IMAX Darling Harbour

State Significant
Development
Modification Assessment
(SSD 7388 MOD 7)

July 2019

Figure 4 | Roof plan showing proposed open roof area above level 22 pool area (Base source: Applicant's Architectural drawings).

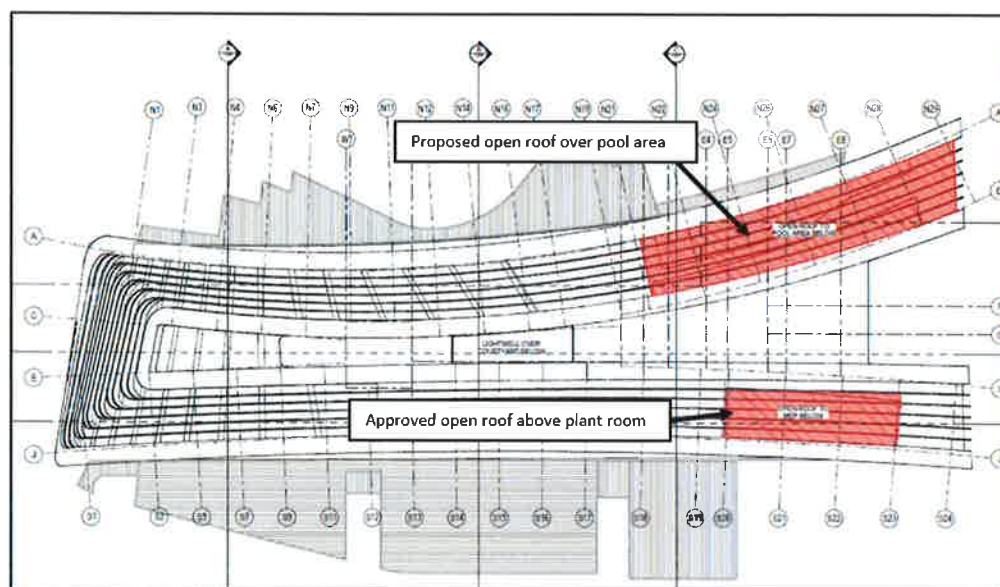
- create an open roof over the level 22 and 23 pool and bar area (**Figures 4 and 7**) including installation of internal Nitrogen Dioxide (NO₂) monitoring equipment and alarm system (**Figures 5 and 6**).
- allow the use of balconies, terraces and operable windows above a height of 60m above ground level (Condition B30)
- allow operable roof louvres to be opened outside of scheduled maintenance and repairs (Condition F2).

Figure 6 | Level 22 plan showing location of NO₂ monitors and alarm (Source: Applicant's Architectural drawings).

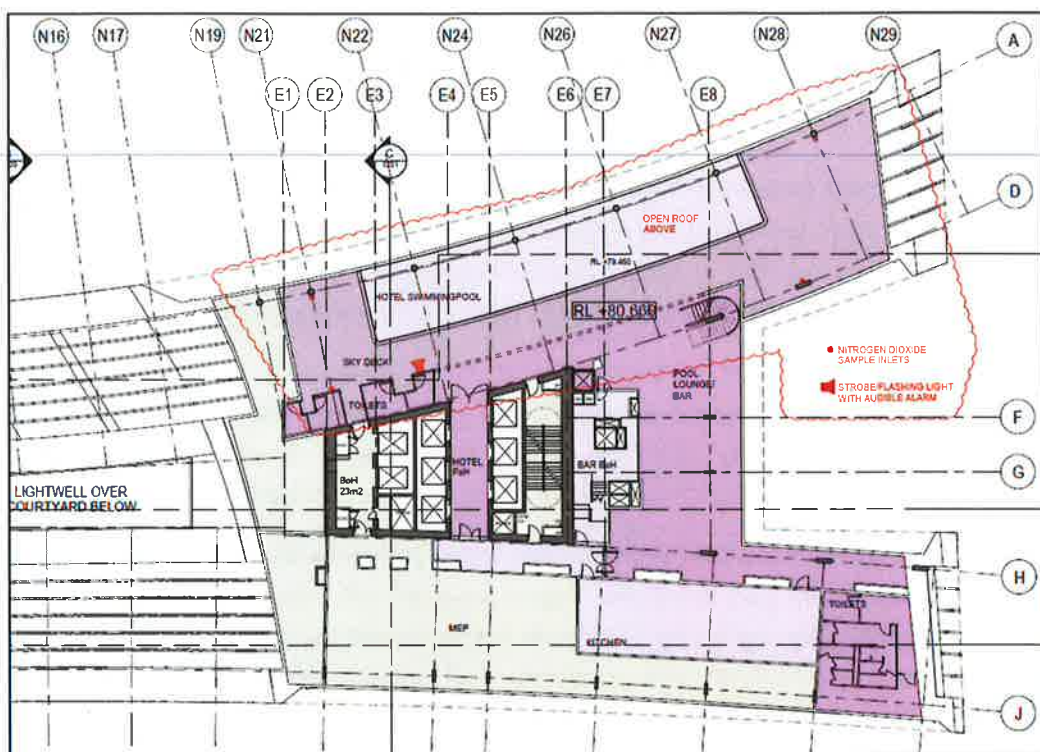
To ensure the safe operation of the pool area during both normal circumstances and in the event of an incident within the CCT, the Applicant proposes to install NO₂ monitoring equipment within the level 22 and 23 pool area which will inform the monitoring/alarm protocol proposed in the AQA (**Table 5**).

- o the adoption of the NO₂ monitoring, safety and evacuation protocols identified in the AQA and plan of management
- o instrument calibration records for air quality sensors to be made available on a quarterly basis to TCCT as requested.
